Our ref: 3136365-38836
Your ref:

Officer PSP Buffer Assessment Review Updated Directional Buffer

Victorian Planning Authority
Officer PSP Buffer Assessment Review

Figure A

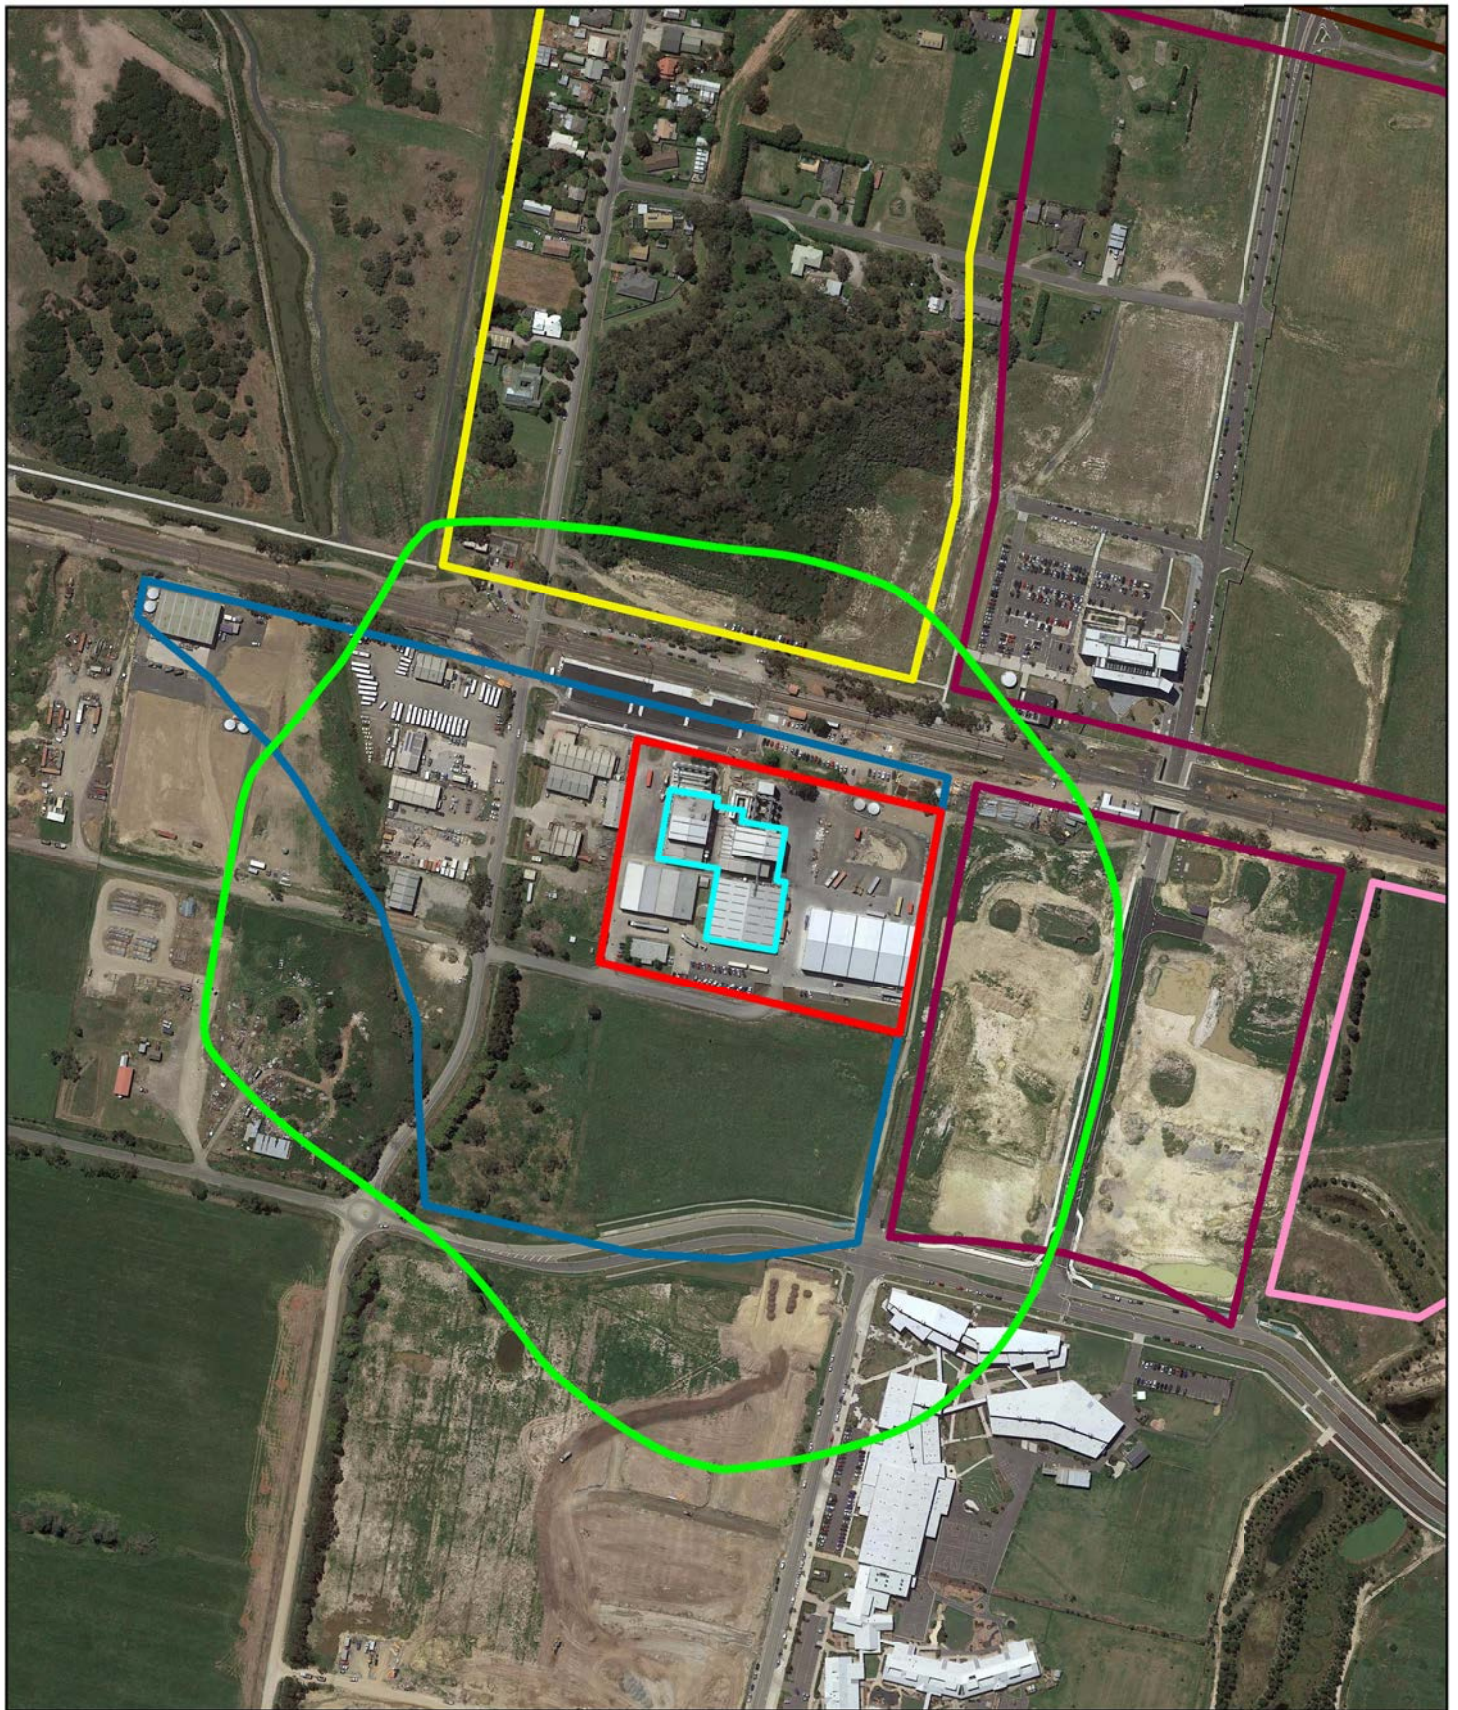
GHD has prepared an updated directional buffer for the HyGain site at Officer to account for a change to the envelope of sources. The changes to the envelope of sources are described below:

- Material processing buildings are included in the envelope of sources, specifically process areas where heat is applied to materials. These areas are included in the source envelope to account for emissions of odours with the potential to lead to off-site nuisance in the event of upset conditions.

- All air extraction systems and dust removal systems are included in the envelope of sources. These sources are located at the sides of processing buildings considered above. These areas are included in the source envelope to account for non-routine elevated levels of particulate emissions due to events such as ‘holes in dust socks’. HyGain has indicated¹ that these events could be expected to take place at a frequency of once per year.

- The following emission sources are excluded from the envelope of sources as they are identified as having routine emissions of either odour or dust, but with little potential for upset conditions leading to elevated levels of emissions:

- Wheel generated dust
 - Dumping of grains/unloading of trucks
 - Silos
 - Warehousing of products
 - Loading to trucks

The updated buffer is attached in Figure A below. Note that all changes to the buffer are based on modifications to the envelope of sources only. No adjustment has been made to the meteorological data or pattern of dispersion.
